EB-2023-0200 – Sandford Expansion Project Leave to Construct Pollution Probe Interrogatories to Applicant

Enbridge Gas Inc. Sandford Community Expansion Project Leave to Construct

POLLUTION PROBE INTERROGATORIES

Figure 1: Energy Savings (percentage) for a ccASHP compared to natural gas, oil and baseboard electric.

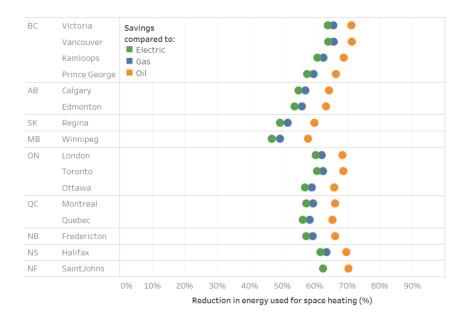
The CanmetENERGY cold-climate air source heat pump (ccASHP) Report shows a ccASHP is 50% to 70% more efficient than natural gas, oil or resistance (i.e. baseboard) electric.

a) Please indicate whether this information for ccASHPs was shared with potential customers as part of the information related to heat pumps. If it was, please provide a copy of the information/materials provided to consumers.

b) This information was provide in EB-2022-0200 based on a 2022 Study. If Enbridge has a more recent/relevant study/information that provides a different savings rate for ccASHPs vs. natural gas, oil or electric resistance heating, please provide a copy.
